ADDENDUM NO. 8

Project: Missoula Garden City Compost Improvements Project

Date of Addendum: March 27, 2025

Sheet
D-1

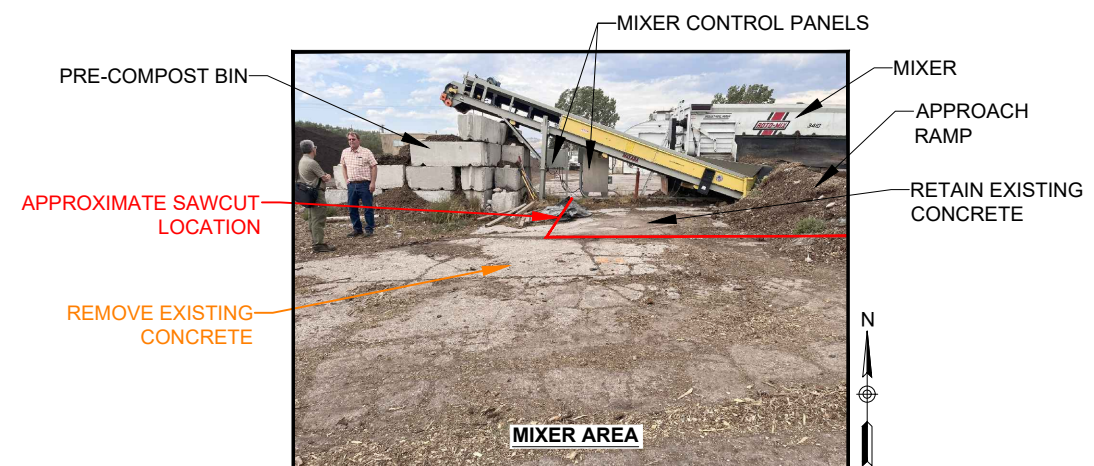
1. A Bidder asked for further clarification regarding demolition scope for the two electrical panels for the existing mixer. An additional note clarifying the intent has been included on Sheet D-1. See Exhibit A.
2. A Bidder asked for clarification on the anchor bolt material for blowers/equipment. See Exhibit B for revised Sheet S-5, Detail 3.
3. The Engineer issued Addendum #7 allowing for larger pours up to 60'x60' and revising Sheet S-9. See Exhibit B for similar revisions to Sheet S-10. *Checkerboard pour pattern and Detail 1 on Sheet S-4 are still applicable for both control joints and construction joints.*
4. A Bidder pointed out an error: Sheet S-15: Note on Detail 2 – EMBED PL $1/2$ "x6"x6" (TYP of $\neq 3$). See Exhibit B for the corrected Sheet S-15
